SITE PLAN REVIEW AND APPEARANCE BOARD STAFF REPORT

Delray Dermatology – 802 SE 5th Avenue

Meeting	File No.	Application Type
September 24, 2025	2024-254	Level 2 Site Plan
Property Owner	Authorized Agent	
802 SE 5 th Ave LLC	Randall Stofft Architects

(Full-sized site plan available as an attachment)

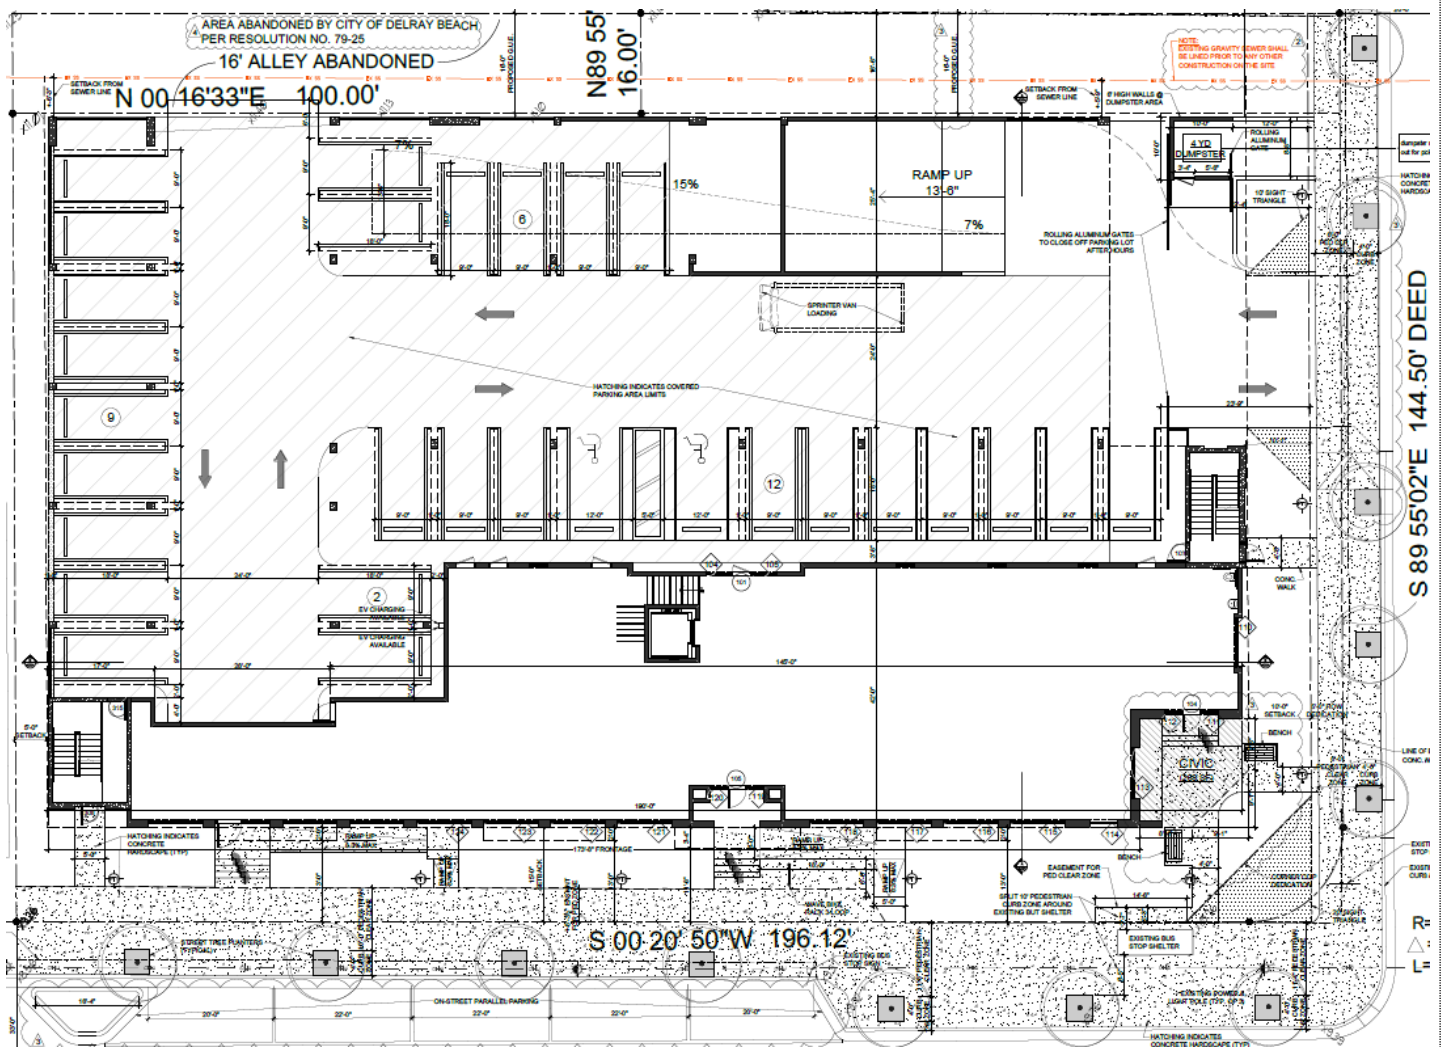
Required parking is provided in a ground-level garage that is successfully lined by office and retail uses which screens the parking from view along the Primary Streets. An exposed second-level parking deck provides additional required parking. Landscaping has been added to the deck so as to improve the visible appearance from the adjacent properties while simultaneously aiding in the reduction of urban heat islands. Additional on-street parking is proposed along SE 5th Avenue which, while not permitted to count towards required parking, will be available for customers and employees to use as needed.

The minimum streetscape dimensions are provided in a way that maintains the maximum feasible pedestrian clear zone, while still allocating sufficient area for foundation landscaping and curb zone landscaping, which helps soften the starkness of the urban environment, and provides buffered protection between the pedestrian and vehicle travel lanes. The applicant and staff have worked closely to strike a balance between providing landscaping within the streetscape while ensuring that more than adequate clearance is provided for pedestrian traffic.

The clear zone has been routed to ensure that existing above ground infrastructure does not obstruct the pedestrian path, and likewise, a substantial street tree canopy is proposed along the full extent of the property.

A small amount of civic space is required based on the overall square footage of the property which has been integrated into the site at the NE corner, accentuating the corner of the building and defining the primary building entrance.

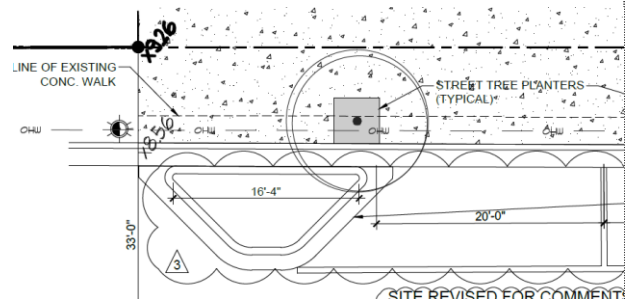
The project proposes a 16'4" landscape island at the SE corner of the development site whereas the LDR requires a minimum depth of 22' for islands. The reduction is predicated on the fact that, in order to extend the island to 22', the island would be required to extend beyond the subject property line. However, the drive-aisle curb cut providing access to the adjacent property is located close to the property line such that an extension of the island beyond the proposed 16'4" is not feasible. Alternatively, one of the proposed on-street parking spaces could be removed to allow for the full

extent of the 22' island to be placed adjacent to the subject property. However, both staff and the applicant agree that the additional parking space is a net benefit that justifies the provision of a 16' island, as the intent of the regulation is still met.

Staff has no issue with the requested landscape island reduction.

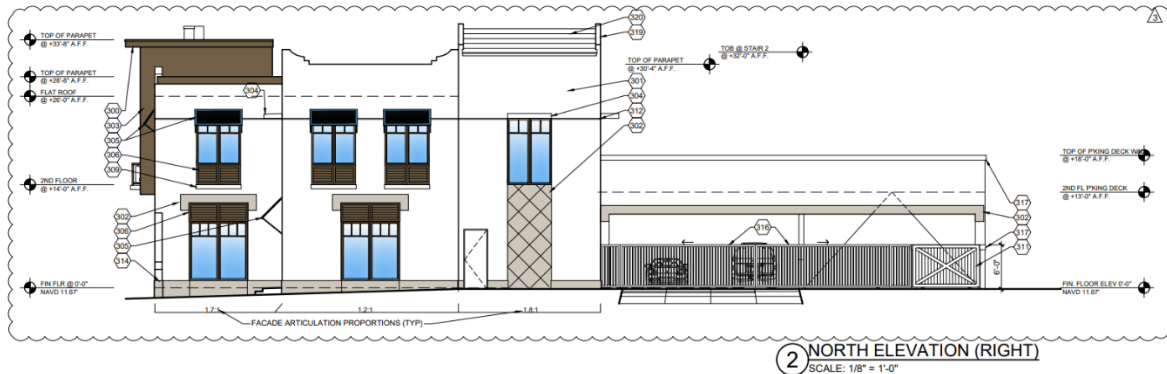
The composition maintains compliance with established façade proportion ratios that allow the building to maintain consistency with the historic downtown scale, and the design successfully incorporates a tripartite composition on the primary street elevation where a clear base, middle, and top of the composition is defined on the two-story structure. However, the side facades lack a defined tripartite element.

Specifically, staff finds that the north elevation facing the secondary street provides a defined base, with the projected masonry stone base, while the middle and top are not clearly differentiated. The Board shall consider whether the intent of the regulation is met or if improvements are necessary on the secondary facades so that they also convey a clear tripartite composition.
